**Comment Response Matrix for
NRC Staff Clarification Questions on
DOE Responses to
Request for Additional Information on the
Draft Basis for Section 3116 Determination and
Associated Performance Assessment for the
H-Area Tank Farm at the Savannah River Site**

January 2014

Prepared by: Savannah River Remediation LLC
Waste Disposal Authority
Aiken, SC 29808

Figure CQ-2.1: Comparison of Total Initial Curies of Cs-137 for All HTF Sources

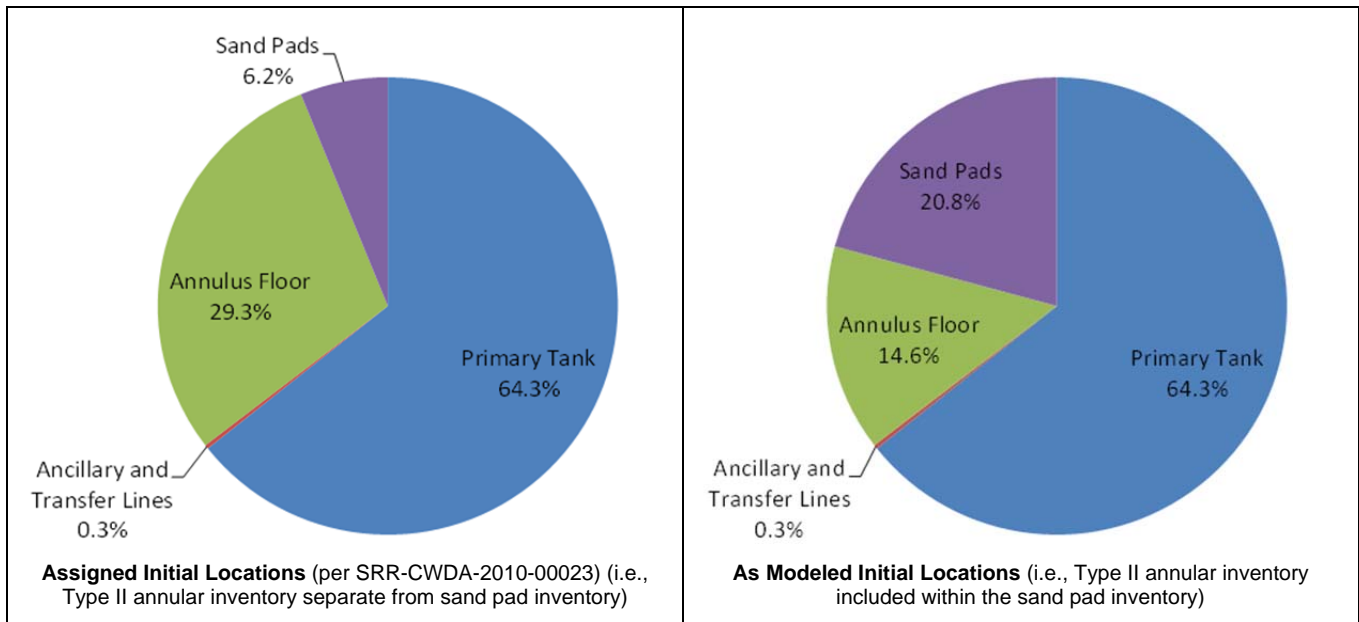
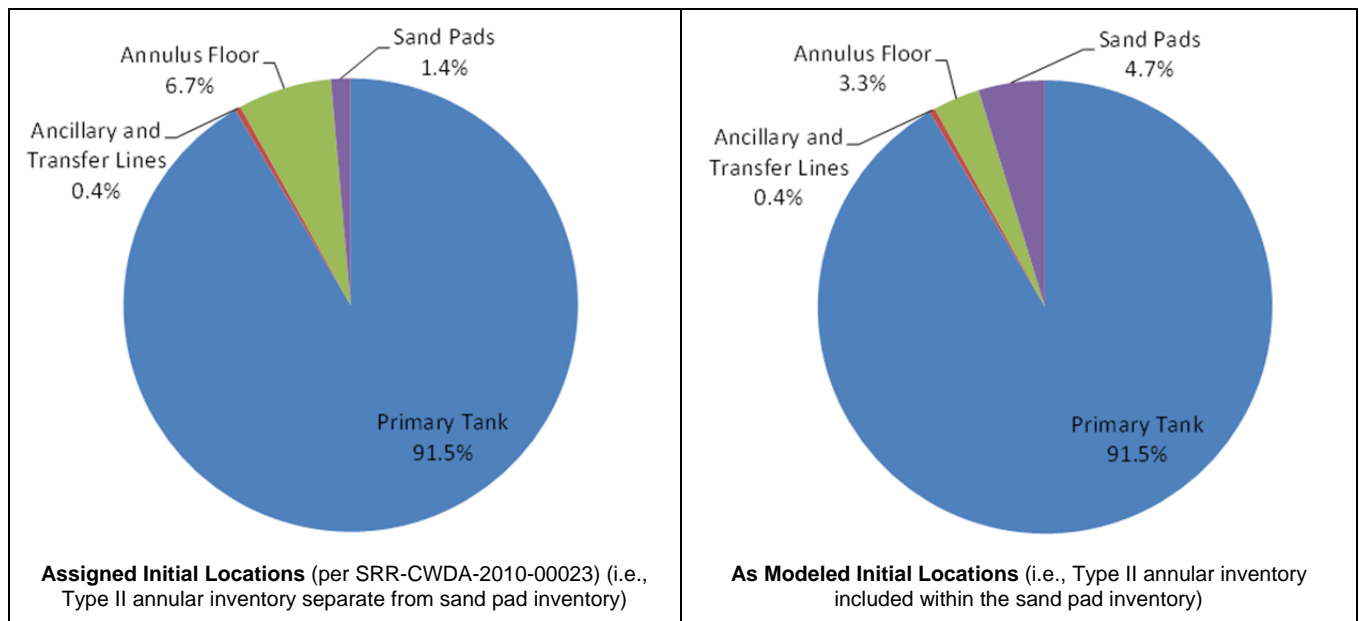
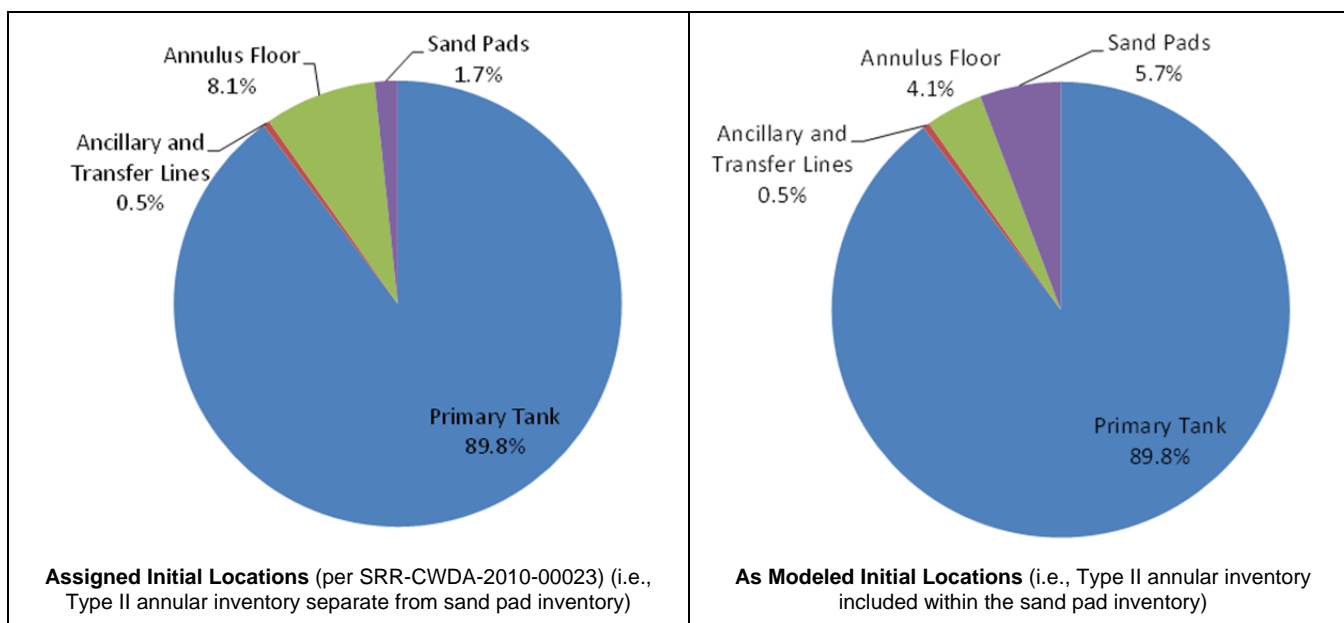
It is not clear to NRC staff whether DOE's response to RAI-NF-12, which relied on an analysis described in RAI-NF-8, adequately accounts for annular inventories. Please provide a table of the fractional release of Cs-137, Sr-90, Tc-99 out of the tanks and the mass storage in tank materials (e.g., sand pads, contaminated zone, basemat, annular grout, tank grout, tank wall concrete, preferential flow paths) over time for the analysis provided to respond to RAI-NF-12.

Figures CQ-2.1 through CQ-2.3 provide graphical representations of the initial inventory locations for Cs-137, Sr-90, and Tc-99, respectively, for the entire HTF inventory. These figures show the entire inventory for each material zone as summed over the entire tank farm. The figures provide a comparison of the "assigned" inventory¹ (i.e., with the sand pad and annular inventories separated in the Type II waste tanks) versus what was modeled for the HTF PA and for the RAI Response Document (i.e., annular inventories included within the primary sand pad zones for the Type II waste tanks). Note that the pie charts for the "as

modeled” inventories still include an annulus floor component which is associated with Type I waste tanks. These figures demonstrate that regardless of the assumed initial location of the Type II waste tank annular inventories (i.e., primary sand pad or grouted annulus material zone), the full inventories were considered and the bulk of the total inventory for each radionuclide is initially within the primary tank liner.

Figure CQ-7.1: Low Zone Outside H Area Southwest of HTF (Wells with Residuals > 6 foot)

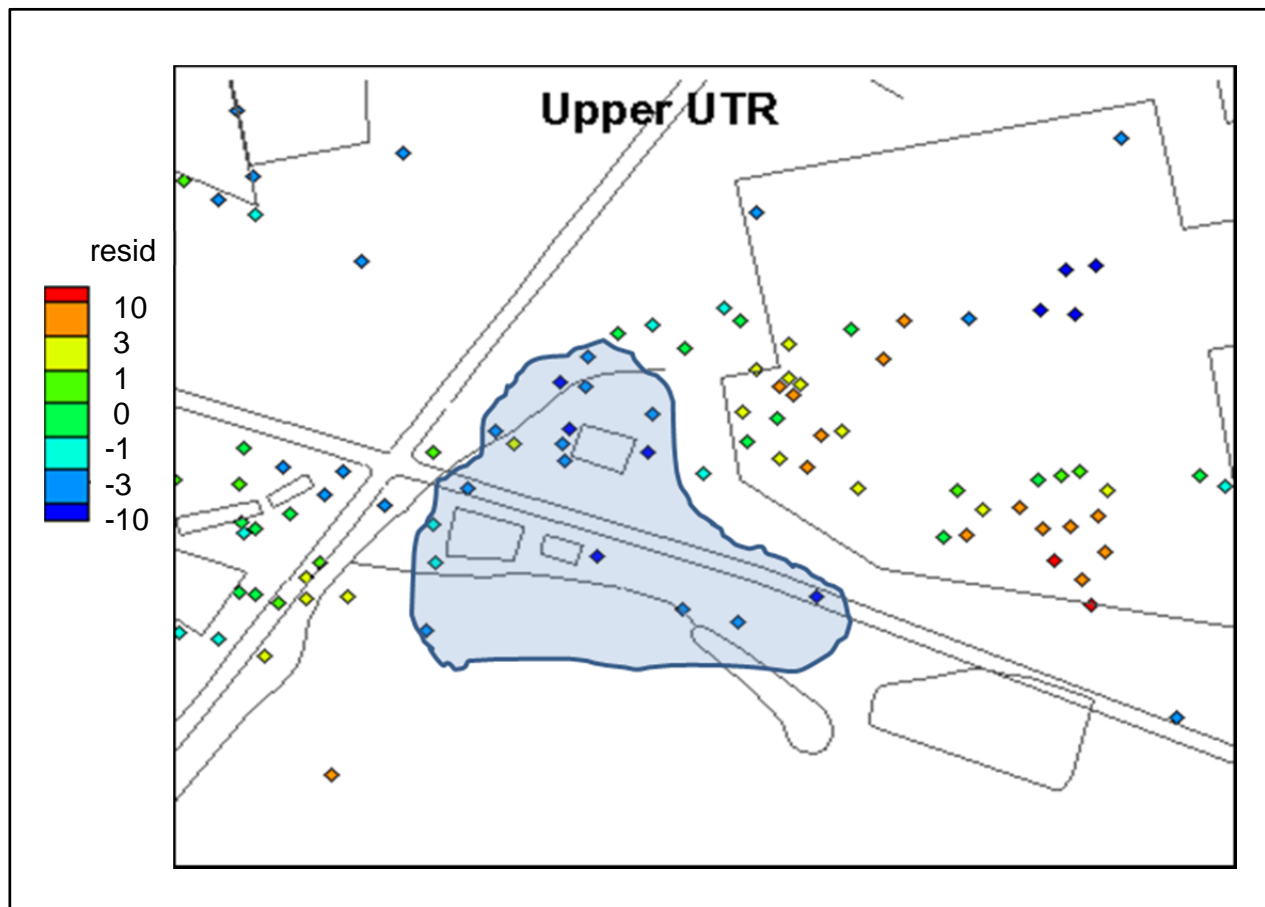
Please provide a legend for Figure RAI-FF-1.1.

The legend for Figure RAI-FF-1.1 from the RAI Response Document is the same as that used in Figure RAI-FF-1.2. Figure RAI-FF-1.1 is reproduced below with the addition of a legend for identification of well residuals values, measured in feet.

Figure CQ-9.1: UTRA-LZ Calibration Residuals (ft)

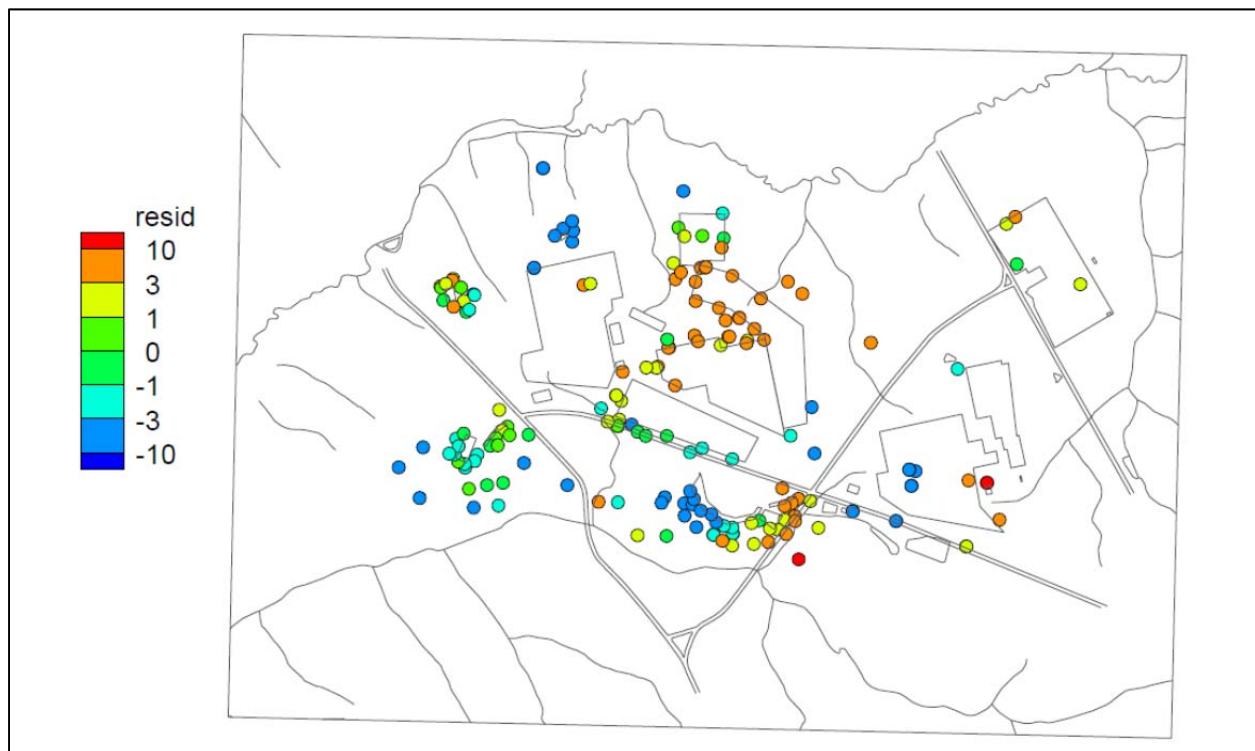
If no UTR-LZ calibration targets were evaluated in Table RAI-FF-2.4 for HTF, please comment on whether UTR-LZ calibration targets are available and on DOE's ability to evaluate HTF PORFLOW model calibration given the strong vertical gradient at HTF.

A few UTRA-LZ targets were available in the vicinity of HTF and were considered during calibration of the GSA/PORFLOW model. The calibration results for the UTRA-LZ targets are indicated in Figure 3-4(b) of *Groundwater Flow Model of the General Separations Area Using PORFLOW*, WSRC-TR-2004-00106, reproduced here as Figure CQ-9.1.

Figure CQ-11.1: 100-Meter Concentration Breakthrough Curves for 5-Year Pulse Release

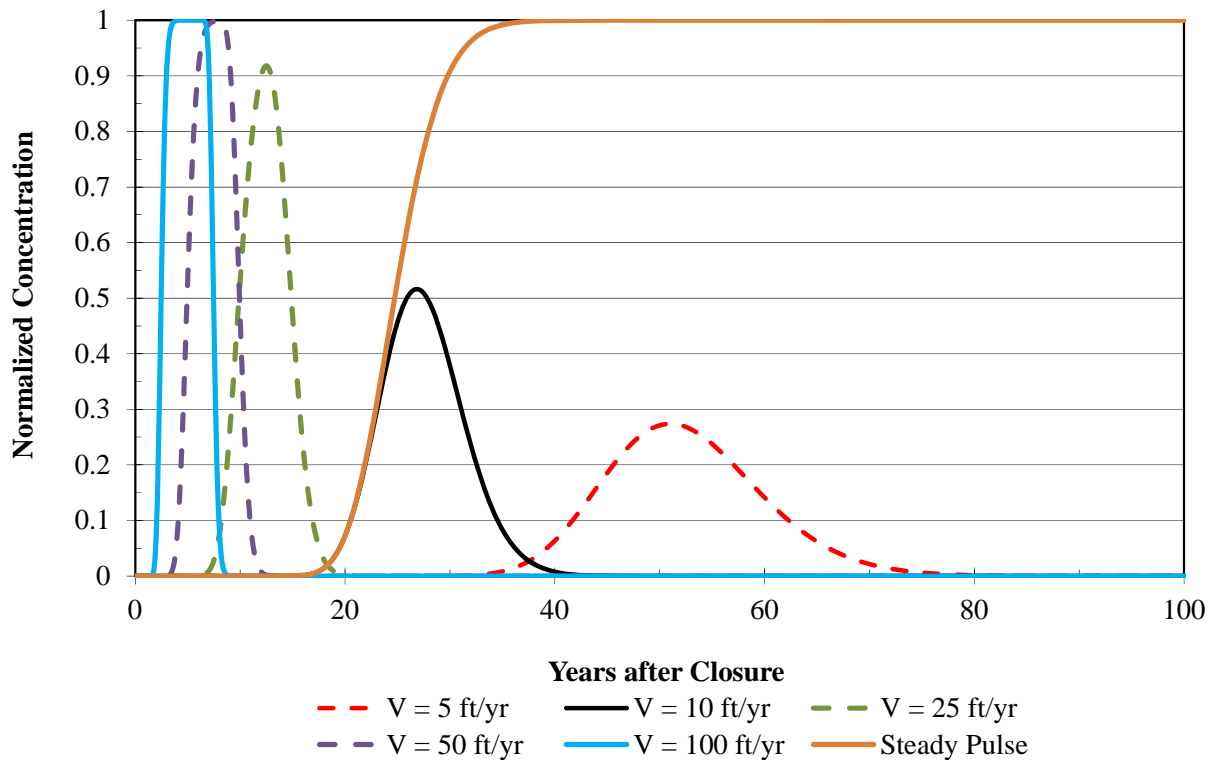
Please explain why Darcy velocity is not expected to impact longitudinal dispersion in the GoldSim model (see CC-FF-4 response on page 195).

The combined influence of the Darcy velocity and release profile will also influence the geometry of the plume. For a pulse release, the length of the pulse and velocity of the flow field together determine when and if the breakthrough curve reaches a quasi-steady state, and for how long the quasi-steady state condition will continue. For example, consider the results for the 5-year pulse simulation presented in Figure CC-FF-4.1 of the RAI Response Document. To show the combined influence of the flow rate and pulse duration, the 5-year pulse model was simulated using the updated velocities of 5 ft/yr, 25 ft/yr, 50 ft/yr, and 100 ft/yr. Note that the mass flux applied was also adjusted by factors of 0.5, 2.5, 5, and 10, respectively making the boundary concentrations, $C_o(t)$, the same so that dilution associated with the vadose zone/saturated zone water flux balance, was negated. The results are presented in Figure CQ-11.1. Notice how the changes in Darcy velocity influence the width and location of the breakthrough curve and how close to reaching a quasi-steady state condition each breakthrough curve comes. In the 100 ft/yr breakthrough curve a quasi-steady state condition is retained for approximately 3 years. As the velocity increases, the quasi-steady state condition will approach the pulse duration. These results can be anticipated by thinking of the pulse release in terms of superposition of two infinite source breakthrough curves as follows:

where t_{pulse} is the pulse duration and the time dependent boundary condition presented in Equation CQ-11.2 is a constant mass flux rate of infinite duration.
